SUBJECT: Preliminary Grading: Reserve at River Oaks

PC Case No: 2016-17

MEMORANDUM

Re: **Future Pond No. 5 (River Oaks Phase 2) Plan Review**

NOTES:

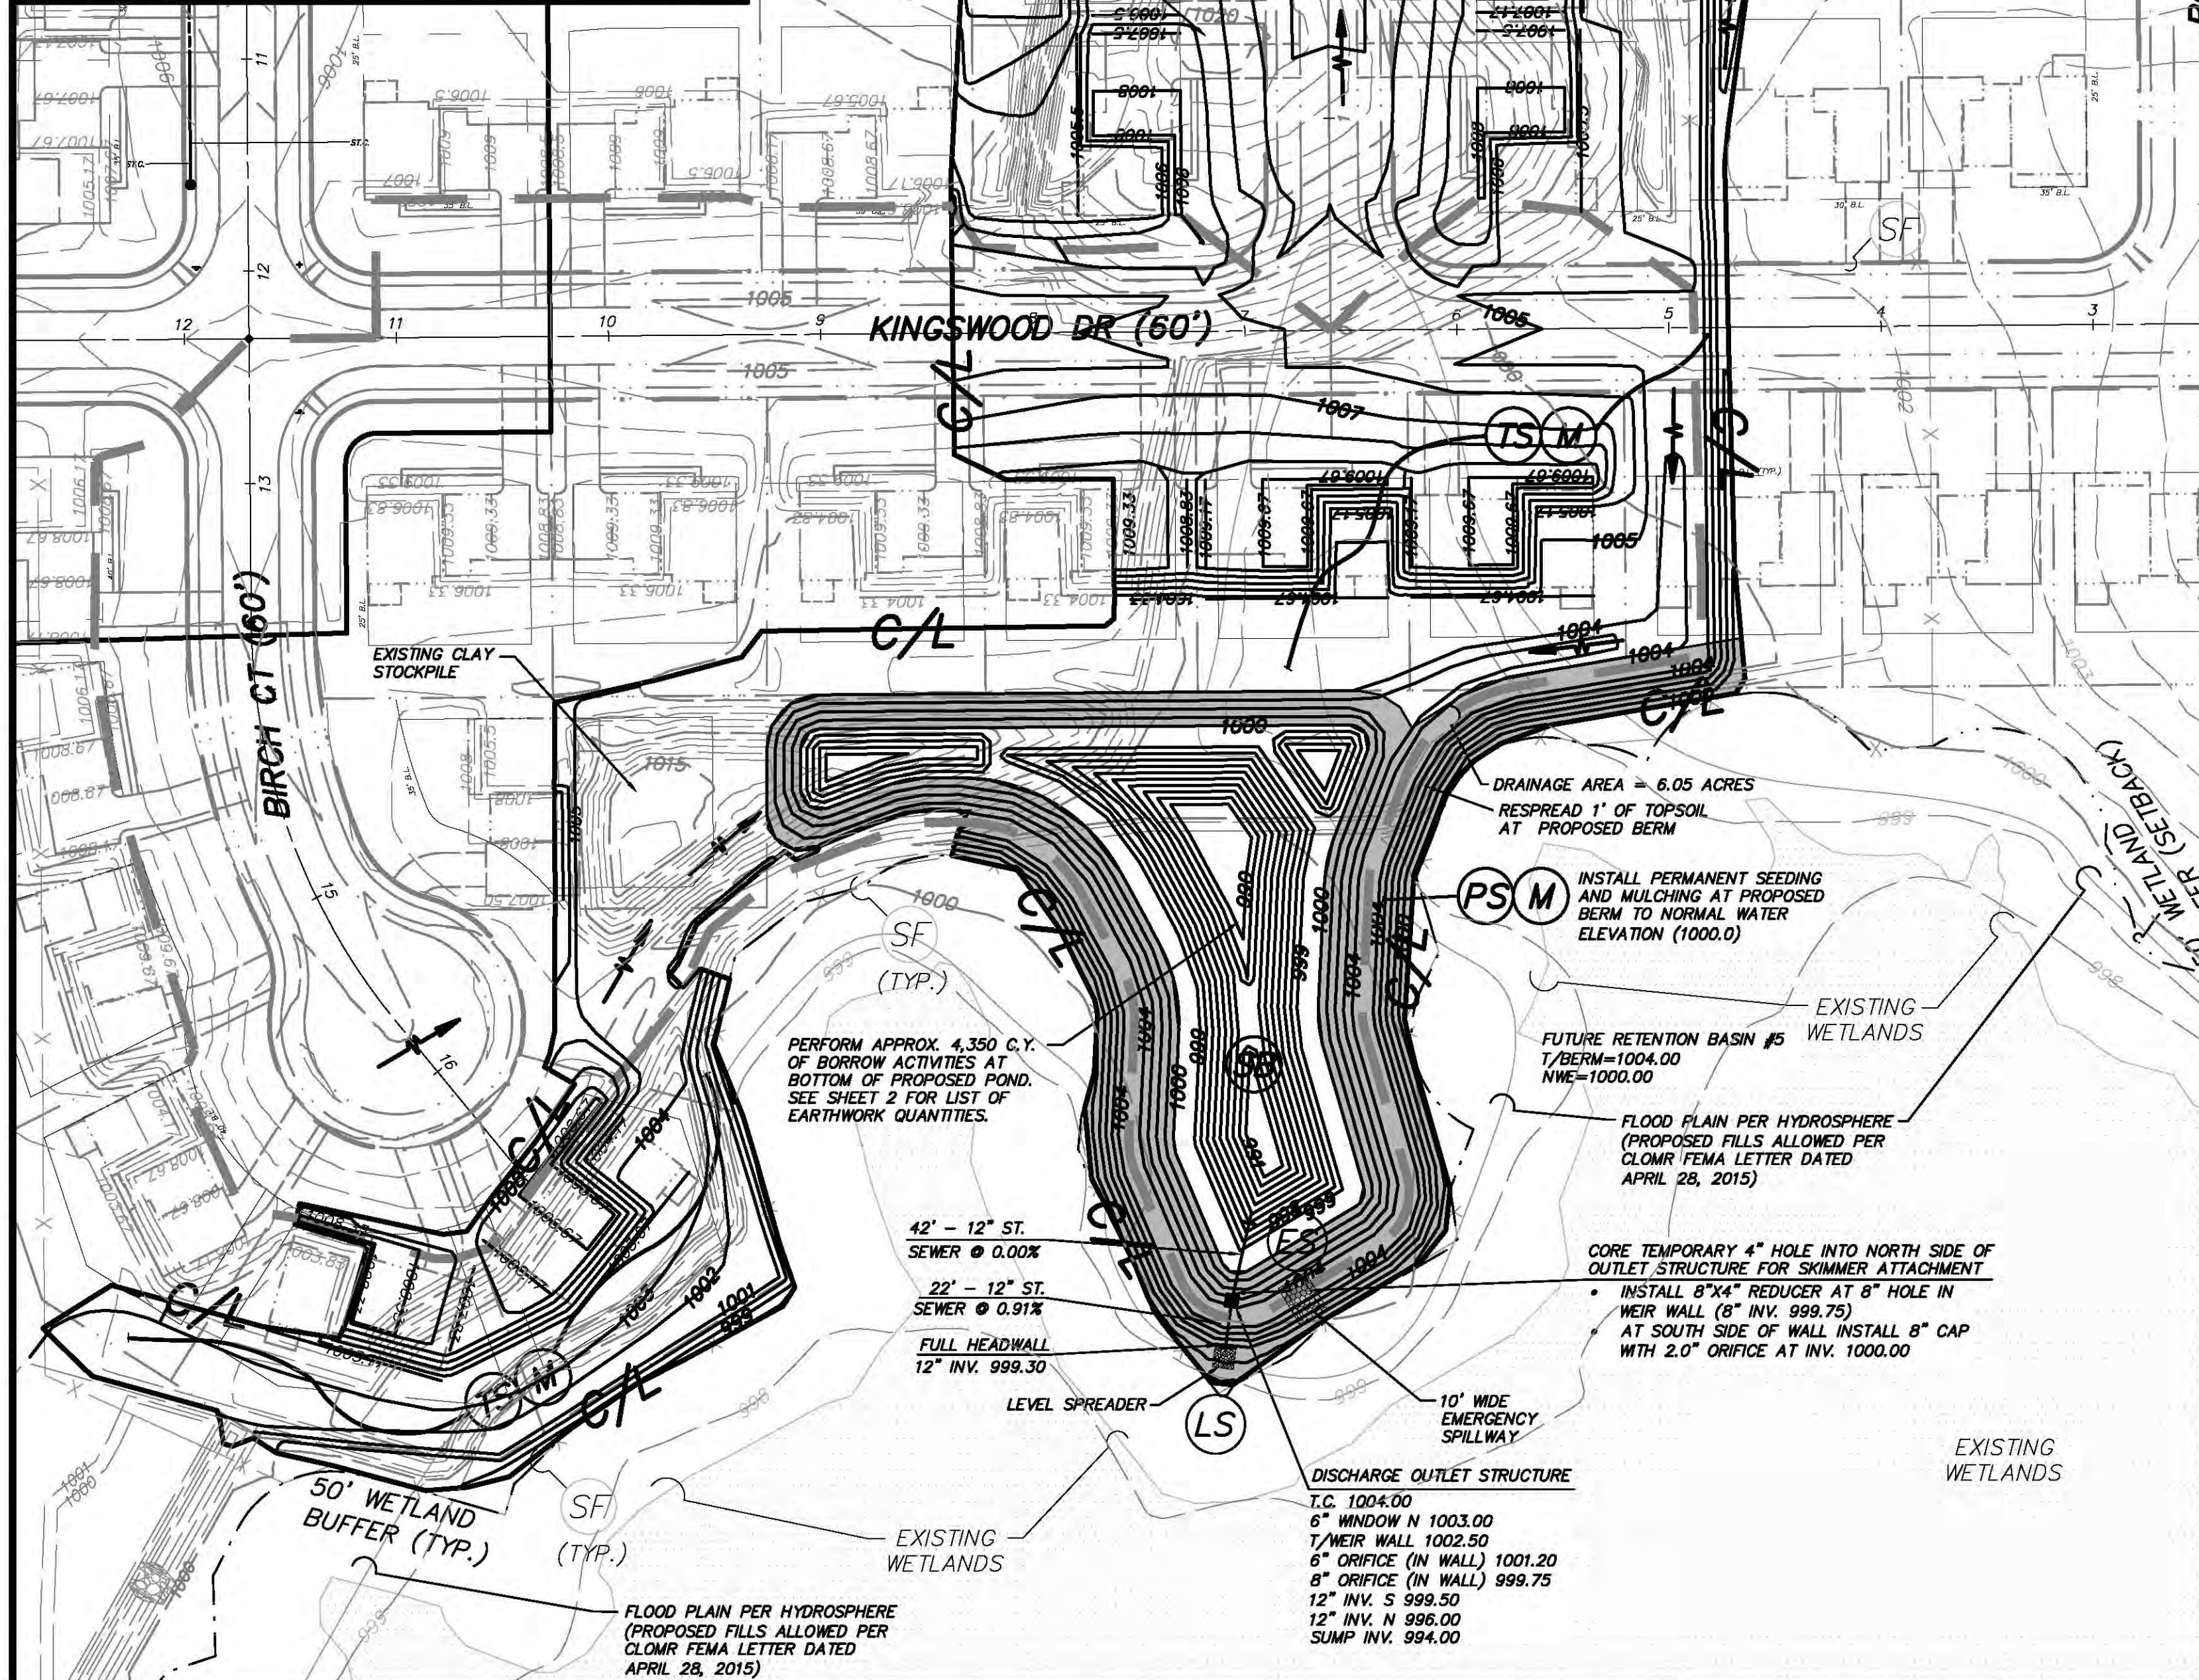
4. Provide approval letter from Summit Soil and Water Conservation District.
5. The plan shows three sets of contours; grey scale (existing), thin bold (future) and thick bold. Please label contour styles or revise drawing to clarify what is being represented.

6. Provide labeling as marked on plan.
